Intersection ID: 2910	Main Street: RIDGEFIELD_DR	Cross Street: SWANSTON_DR	Location:	SW
ADA ID: 1DFBA6157605	Ramp Type: PerpDiag	Initial Pass/Fail: Fail	Overall Compliance: No	Severity Score: 8.75

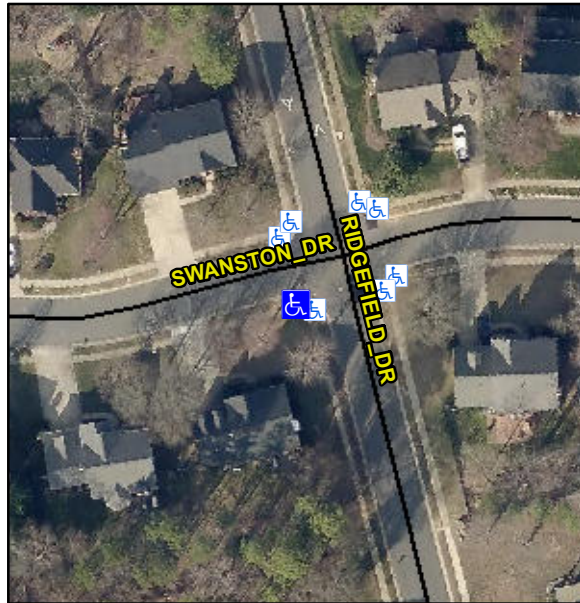
Compliance	Description	Data	Compliance	Description	Data
N/A	Ramp Length (in)	49.0	Yes	Ramp Slope (%)	6.1
No	Ramp Width (in)	36.0	Yes	Ramp XSlope (%)	1.9
N/A	Flare Type LT	N/A	N/A	Flare Type RT	N/A
N/A	Flare Slope LT (%)	N/A	N/A	Flare Slope RT (%)	N/A
N/A	Flare Traversable LT?	N/A	N/A	Flare Traversable RT?	N/A
N/A	Landing Length (in)	N/A	N/A	DWS Provided?	N/A
N/A	Landing Width (in)	N/A	N/A	DWS Contrast?	N/A
N/A	Landing Slope (%)	N/A	N/A	DWS Length (in)	N/A
N/A	Landing X Slope (%)	N/A	N/A	DWS Full Width?	N/A
N/A	Landing Curb? (Y/N)	N/A	N/A	DWS Offset (in)	N/A
N/A	Shared Landing?	N/A			
N/A	Gutter Ponding?	N/A	N/A	Gutter Slope (%)	N/A
N/A	Gutter Lip Ht (in)	N/A	N/A	Gutter X Slope (%)	N/A
N/A	Painted X Walk1?	No	N/A	Painted X Walk2?	No
	X Walk 1 Direction	To E		X Walk 2 Direction	To N
N/A	X Walk 1 Width (in)	N/A	N/A	X Walk 2 Width (in)	N/A
	X Walk 1 Slope (%)	1.6		X Walk 2 Slope (%)	0.4
	X Walk 1 X Slope (%)	1.7		X Walk 2 X Slope (%)	1.8

N/A	Ramp inside XWalk1?	N/A	N/A	Ramp inside XWalk2?	N/A
	Road Slope (%)	1.5	N/A	Clear Space?	N/A
	Road X Slope (%)	1.4	N/A	Clear Space to XWalk (in)	N/A
N/A	Any Obstructions?	N/A	N/A	Storm Grate/Utility Hazard?	N/A
	Obstruction Type			Storm Grate/Utility Type	
		N/A			N/A
			Yes	Surface Condition? (G/P)	Good

**Remove & Replace Curb Ramp With Two New Directional Ramps or Equivalent.**

### R304.5.1
